Project Name: White City Subdivision

Activity White City Subdivision

REVIEW SHEET SUMMARY

TYPE: WHITE CITY SUBDIVISION - FINAL

WESTERN ENGINEERS, INC.  
PLAT OF  
WHITE CITY SUBDIVISION  
CITY OF GRAND JUNCTION  
MESA COUNTY, COLORADO  
SURVEYED \_\_\_\_\_ DRAWN \_\_\_\_\_ CHECKED \_\_\_\_\_  
GRAND JUNCTION, COLO. DWS 2428-871-3 9/13/79

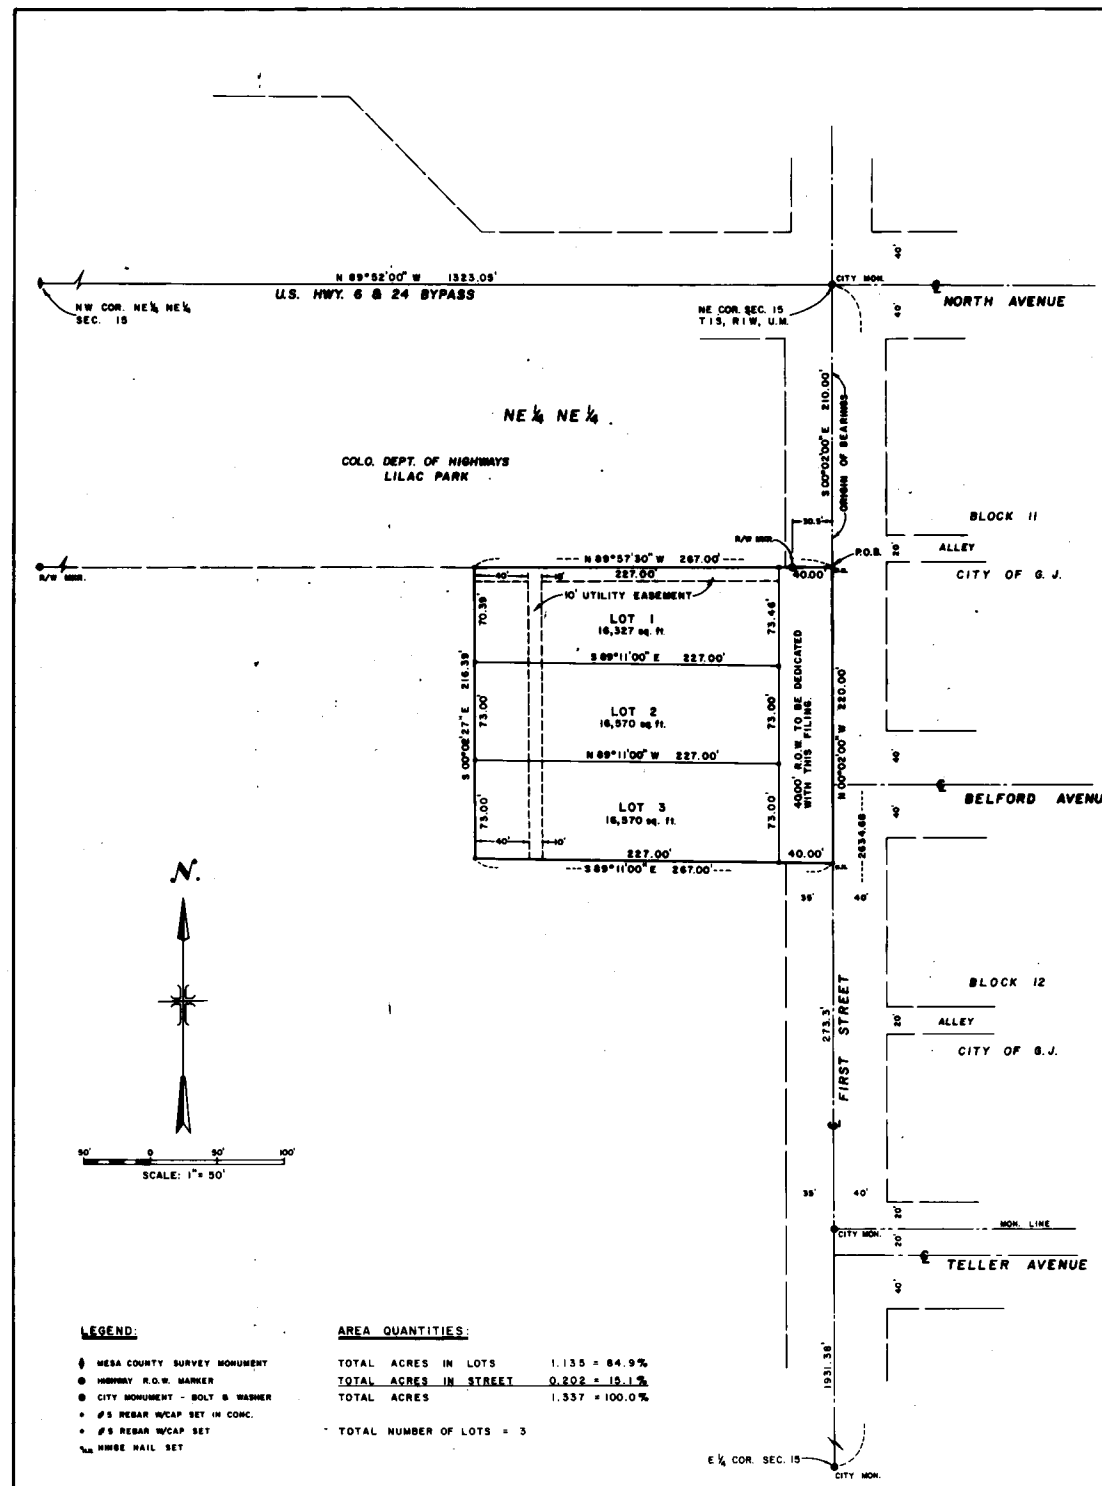
| <u>DATE REC.</u> | <u>AGENCY</u>    | <u>COMMENTS</u>   |
|------------------|------------------|---|
| 10-12-79         | CITY FIRE        | One hydrant is needed at the corner of Belford and 1st to meet fire flow requirements min. line size 8".  |
| 10-11-79         | CITY ENG.        | Proposed site drainage improvements and driveways look reasonable. Sidewalk or power of attorney for sidewalk should be provided on First Street. |

Previous approval of this subdivision was contingent upon the allowal of only two curb cuts on First Street.

| <u>DATE PDC.</u> | <u>AGENCY</u>           | <u>COMMENTS</u>  |
|------------------|-------------------------|--|
| 5-22-79          | MOUNTAIN BELL           | We require ten (10) foot utility easements as highlighted on the attached plat.  |
| 5-23-79          | PUBLIC SERVICE          | Gas: No objection-Gas lines in N. 1st street as shown.<br>Electric: Request 5' easement adjacent to North side of subdivision  |
| 5-24-79          | CITY ENGINEER(RISH)     | 1. Power of attorney for full street improvements and appropriate right-of-way dedication consistent with 1st Street Policy Statement should be provided.<br>2. Existing fill bank on west edge is irregular with broken concrete and other debris and fill dumped on it. Fill construction should be engineered and controlled for stability.<br>3. Appearance of west and north banks from the Park is poor. Some appropriate slope treatment is advised.<br>4. Fill extension to west should not encroach on drainage way and easement for same.<br>5. Fill settlement is acknowledged in their Geology Report as a potential problem.<br>6. If site drains to west, the runoff should be contained and carried over the fill at one or two locations in an improved flume or pipe to prevent fill erosion. Proper treatment at toe of flume(s) will also be necessary to avoid erosion at the toe of fill. |

1. To meet fire flow requirements, one hydrant is needed at the corner of Belford and 1st, minimum line size 8".
2. POA for sidewalk on 1st Street.
3. Limit curb cuts to two off 1st Street on final plat.
